**PLANNING COMMISSION MEETING STAFF REPORT**

**NAME OF PROJECT:** Ameyalli Resort Development

**AGENDA ITEM:** Ameyalli Resort Master Plan

**Subject: Ameyalli – Master Plan Review**

## OVERALL SITE PLAN

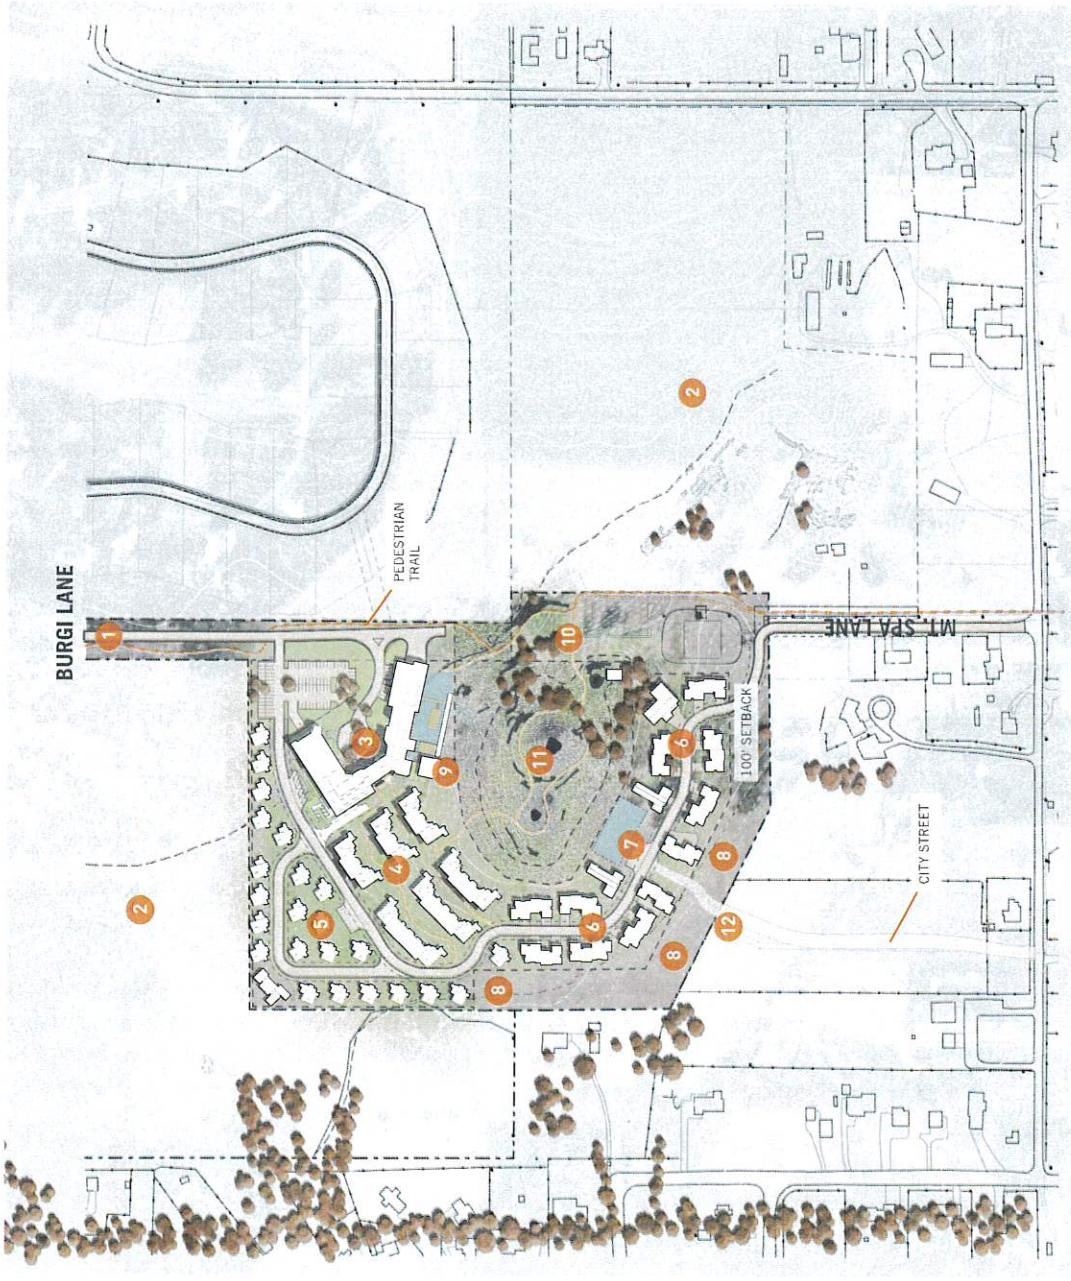
*Open Space* – The code requires 55% open space which is being met with 16.06 acres. Only areas that are a minimum of 100’ in width qualify as open space, these areas shall not be developed except for uses specifically permitted in the code. The open space areas that will be noted on the plat will include the 100’ setback area along the adjoining property boundaries.

*Access* – The development has three access points, two of which will be built to City standards, one from Burgi Lane, one from 600 North via 200 East. The third is an emergency access from Sunflower Lane.

*Setbacks* – The proposed development is designed with the setbacks from the Resort Zone code. The code requires 100’ setbacks from all boundary lines surrounding the original Mountain Spa property. This includes the areas along the southern boundary, Sunflower Farms, property to the west that fronts Center Street, and along the boundary with the Lacy Lane Estates. The four Mountain Spa Rural Preservation lots that were developed by the applicant and were part of the original Mountain Spa Resort property, all have minimal setbacks because those properties are part of the master proposal and are considered part of the resort property as approved in the previous plan (2008 master plan approval).

*Building Area Dimensional Limitations* – The code requires that building coverage not exceed 12,000 square feet per acre or greater than 27.5% of an acre. The applicant has submitted a plan that states that the average building coverage 229,938 square feet (5.27 acres) per acre which is 18.3% per acre.

1. A preliminary light mitigation plan must be submitted to the City, and agreeable to the City, that will mitigate the potential impact to the surrounding residents.
2. More detail must be submitted to determine that the required parking has been met.
3. Water rights must be updated and calculated per phase.

## PARKING COUNTS

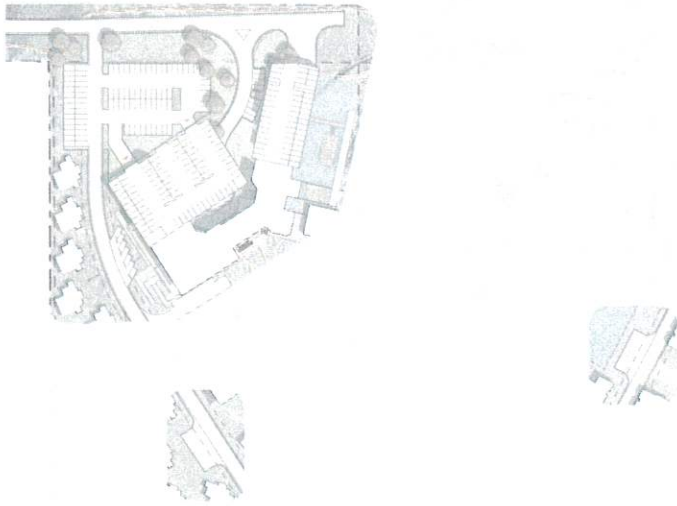
*Parking Plan Proposal* – The applicant has submitted a site plan with parking stalls included. A parking plan is required at the master plan stage of the process as part of the dimensional limitation plan. With the scale of the master plan, it is impossible to review every stall and access for code compliance, this will happen at preliminary review of each phase. It is a possibility that buildings will need to be adjusted and possibly removed to meet the required parking requirements. Midway City code does allow for the reduction of parking stalls for mixed-use developments in Section 16.13.39 E which states the following:

Preliminary calculations show the required parking is 680 stalls for the resort. The applicant has submitted a parking analysis for the resort, using recognized studies, that reduces the required parking to 302 stalls. The resort site plan includes 335 stalls (must be reviewed when more detailed site plans are submitted). The City Council will need to decide if the provided analysis will be accepted to reduce the required parking.

# **Exhibit 3**

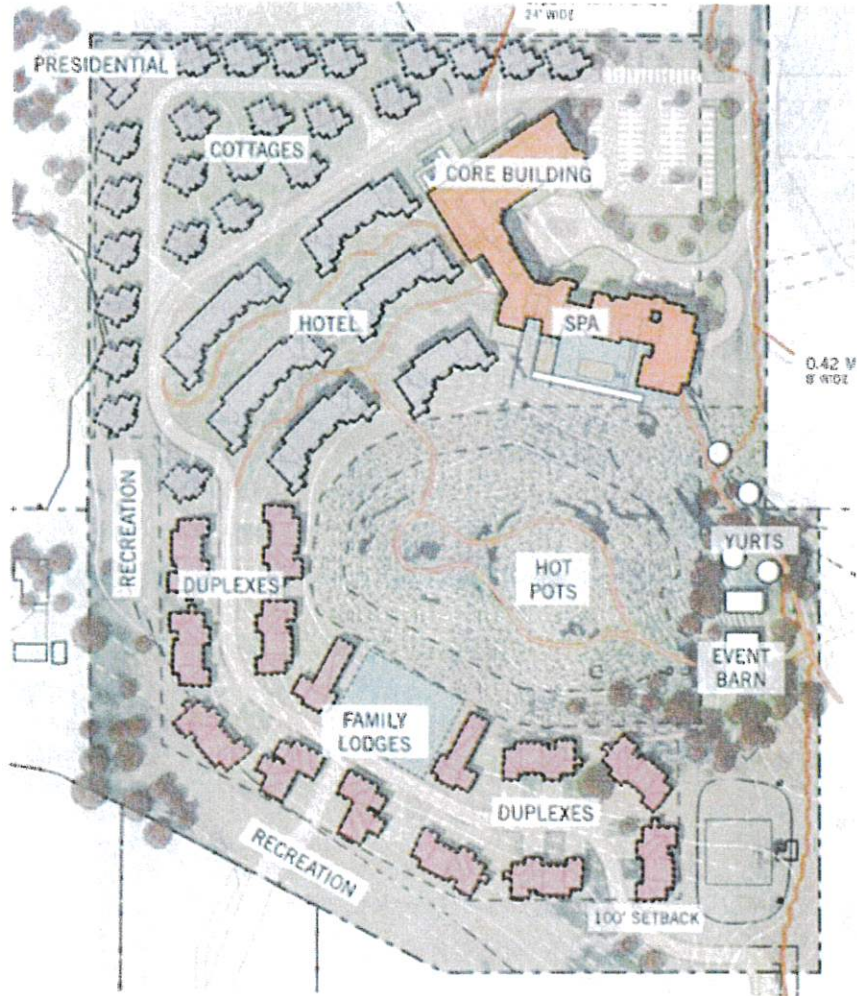
*Landscaping Plan* – A detailed landscaping plan has been submitted which shows irrigated areas, ground covers, and types and quantities of trees. The code requires 15 trees per acre for non-hard-surface common areas. Based on the plan, 326 trees are required, and the plan shows a total of 358 trees. The plan also shows the area that will be landscaped which will be used obtain a more accurate calculation for the water rights required for the project.
